FOREST GLEN ROAD SIDEWALK FACILITY PLANNING STUDY BRIEFING

The Montgomery County Department of Transportation (MCDOT) will provide a project briefing on pedestrian and bicycle improvements proposed on Forest Glen Road between Woodland Drive and Sligo Creek Parkway. Planning Staff is seeking Planning Board comments on two concept options developed by MCDOT as well as two alternative concepts identified by Planning Staff.

MCPB
Item No. 5
10-06-2022

Figure 3 – MCDOT Option 1 Cross Section

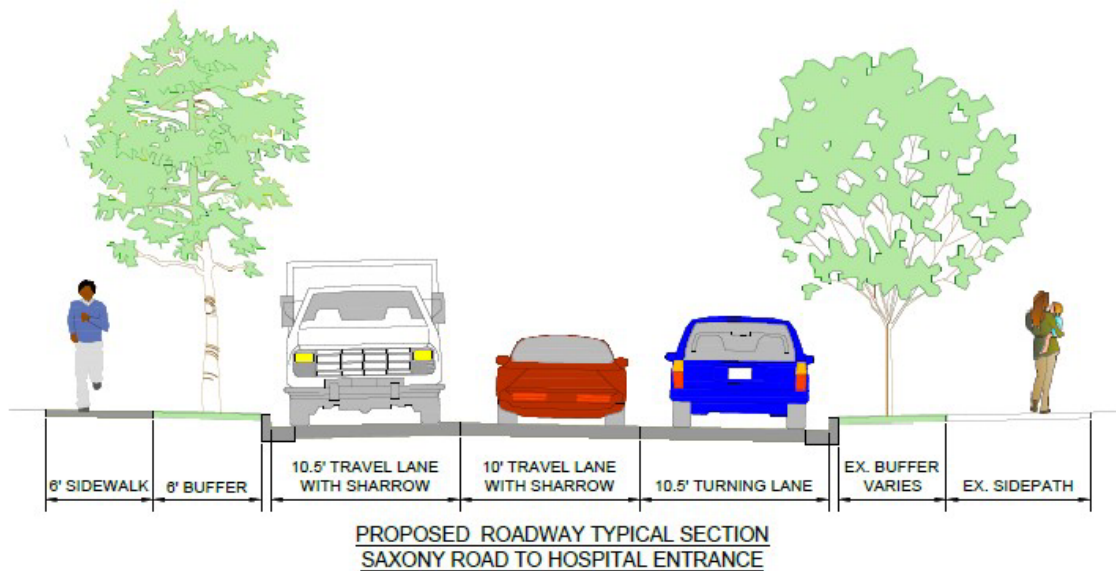
MCDOT Option 1

- The six-foot-wide sidewalk on the north side of Forest Glen Road is consistent with the CSDG.
- Despite what is shown in the cross section in Figure 3, the proposed buffer on the north side of Forest Glen Road for most of the corridor is less than the CSDG minimum buffer width of six feet.

- The proposed through travel lane widths on Forest Glen Road are consistent with the CSDG.
- The existing buffer on the south side of Forest Glen Road varies considerably (0 to 22 feet). There are some segments where the buffer is less than six feet.

- The existing sidepath on the south side of Forest Glen Road is only eight-feet wide, which meets minimum CSDG standards; however, this minimum is typically used only in environmentally constrained areas.

- The existing sidepath on the south side of Forest Glen Road does not extend to the project limits (Sligo Creek Parkway). This is inconsistent with the Bicycle Master Plan and the Forest Glen/Montgomery Hills Sector Plan.

Figure 4 – MCDOT Option 2 Cross Section

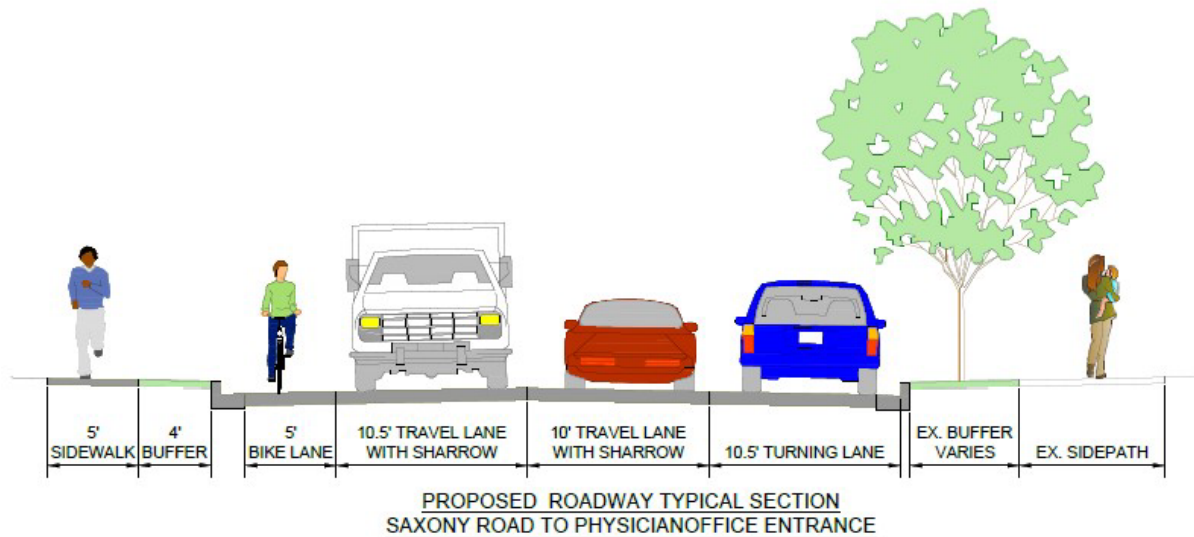
MCDOT Option 2

- The five-foot-wide sidewalk on the north side of Forest Glen Road is not consistent with the CSDG which specifies a six-foot minimum width.
- The proposed westbound bike lane is not included in either the Bicycle Master Plan or the Forest Glen/Montgomery Hills Sector Plan, but can be added per the Bicycle Master Plan if it does not detract from the provision of a sidepath.

- The proposed buffer on the north side of Forest Glen Road ranges from no buffer to a maximum of four feet, and therefore is less than the CSDG minimum buffer width of six feet.

- The proposed through travel lanes on Forest Glen Road are consistent with the CSDG.
- The existing buffer on the south side of Forest Glen Road varies considerably (0 to 22 feet). There are some segments where the buffer is less than six feet.

- The existing sidepath on the south side of Forest Glen Road is only eight-feet wide, which meets minimum CSDG standards; however, this minimum is typically used only in environmentally constrained areas.

- The existing sidepath on the south side of Forest Glen Road does not extend to the project limits (Sligo Creek Parkway). This is inconsistent with the Bicycle Master Plan and the Forest Glen/Montgomery Hills Sector Plan.

Figure 6 – Option 3 - Master Plan Vision Cross Section

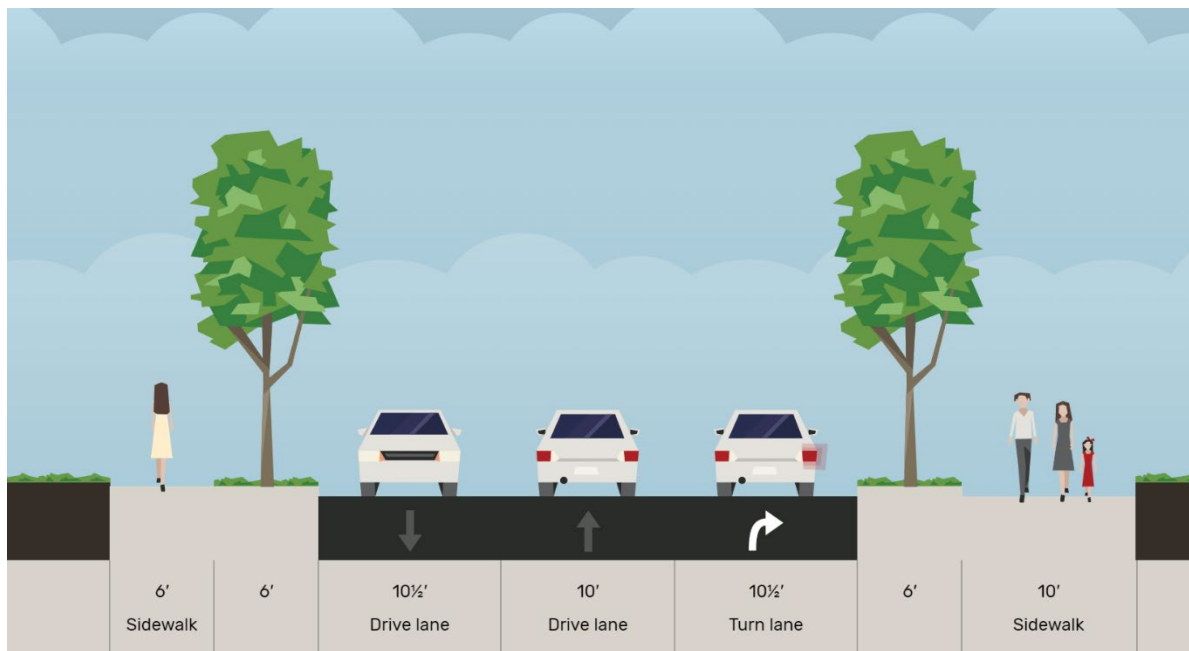
Planning Staff first developed an option to address the long-term master plan vision. Option 3 provides all facilities identified in the Master Plan of Highways and Transitways and with dimensions and priorities from the CSDG. Option 3 is displayed in Figure 6.

Option 3 provides a six-foot-wide sidewalk, six-foot-wide minimum buffers on both sides of the street, two 10.5-foot-wide travel lanes, an exclusive eastbound right-turn lane where it currently exists, and a 10-foot-wide sidepath along the corridor extents (Woodland Drive to Sligo Creek Parkway). This is a generalized cross section (59.5 feet wide) and does not apply uniformly across the study area. The exclusive right-turn lane depicted only exists between Saxony Drive and the hospital driveways.

Figure 7 – Option 4 - Master Plan Vision Cross Section with Climbing Lane

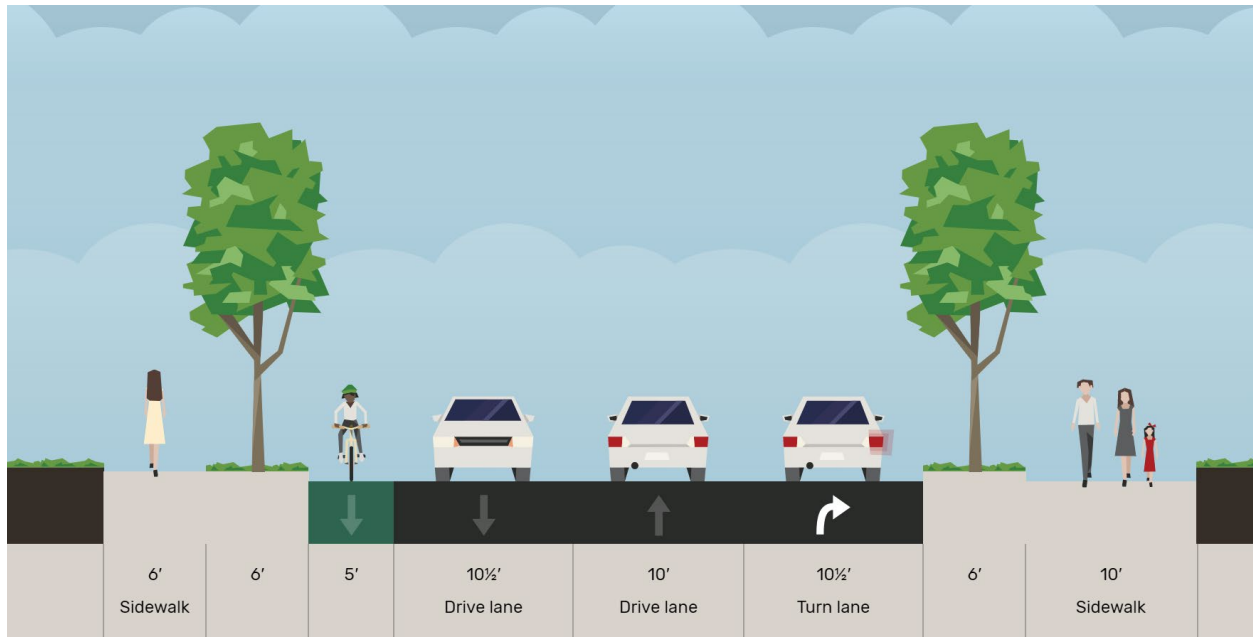
In addition, Planning Staff agrees with some of the concerns raised by WABA. The addition of a westbound bike lane (in the uphill direction) is a great suggestion, despite not being a current master plan recommendation. Planning Staff therefore identified Option 4, which would build on Option 3 with the addition of a westbound five-foot-wide bike lane. This cross section would be 65 feet wide. Option 4 is shown below in Figure 7. Note that the westbound through travel lane shown in Option 4 is 11-feet-wide compared to the 10.5-feet used for Option 3. This additional ½ foot is needed when adjacent to a bike lane to provide a total distance of 16 feet (travel lane plus bike lane).

Based on this very detailed review of the MCDOT and Planning options, Planning Staff recommends the Planning Board endorse Option 4 as the design concept that best matches the Master Plan requirements and the standards in the CSDG and addresses valid concerns from the bicycling community. If the spatial requirements of an uphill bicycle lane create excessive property impacts or costs, staff recommends Option 3. If this option entails prohibitive costs, Planning Staff recommends pursuing Option 1.
